Authors' response to reviewer 1

Authors' response to reviewer 2

Figure 1: Final energy gain in FLORIS on the left and in FAST.Farm on the right

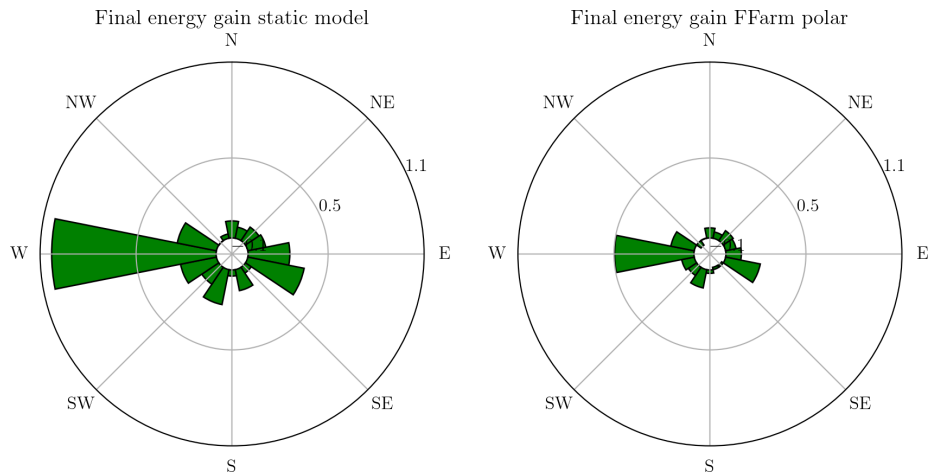
Line 275 - the gain of 1.4% might be within the modelling error and is insignificant

Thank you for this comment. We have added context to explain why the 1.4% gain is significant.

- The 1.4% is a small value when we do not consider the value of the wake losses. However as shown in Table 4 newly added to the text the new design leads to decreasing the wake losses from -6.08% to -4.73%. This decrease is equivalent to a decrease of wake losses by 22%. The gain in our work is only 1.4% because we used the optimized wind farm layout OWFL as a baseline for comparison. We decided to do this instead of using a gridded shape layout to truly show the benefit of relocating the FOWT. Starting with a gridded shape layout would lead to a much higher gain value as the gridded layout has higher losses. We are currently working on a paper showing that for wind farm layouts that are gridded shaped similar to the Horns Rev I wind farm, this method has a much higher potential as any small relocation will significantly increase the power. Tables 3 and 4 are now added to the text to show the wake losses of each layout.

- There is a big uncertainty from the wake model implemented within FAST.Farm as we discuss in the paper. However, FAST.Farm currently underestimates the wake losses for a FWF. As we discussed in the paper the work done in [3], compared the FAST.Farm results to MIRAS-HAWC2 results. The results show that FAST.Farm over estimates the vertical deflection of the wakes due to the pitching of the FOWT. This overestimation decreases the wake losses predicted by FAST.Farm and this is explained in section 3.4. Therefore, the uncertainty in the wake model decreases the

energy gain due to relocating the FOWTs and does not increase it.

- In Figure 11, that we zoom in and introduce again here, the final gain expected from the static model and the gain from FAST.Farm follow the same pattern. If the gain was due to numerical uncertainty the gain distribution over the wind directions will be random and would not agree with the predictions of the static model. This is explained in the paper in section 3.4 in line 290. The text is now updated as follows: “The energy gain distribution per wind direction in the FAST.Farm model follows the same trend as the gain distribution for the MoorPy-FLORIS results. This shows that the energy gain achieved by the OWFL when coupled to the OWFL, is not numerical as it is not random but follows our expectations from the steady state model.”

- In section 3.3 we showed that the lateral movements of the FOWTs and OpenFAST match each other. This minimizes the probability of the gain being a numerical modelling error.
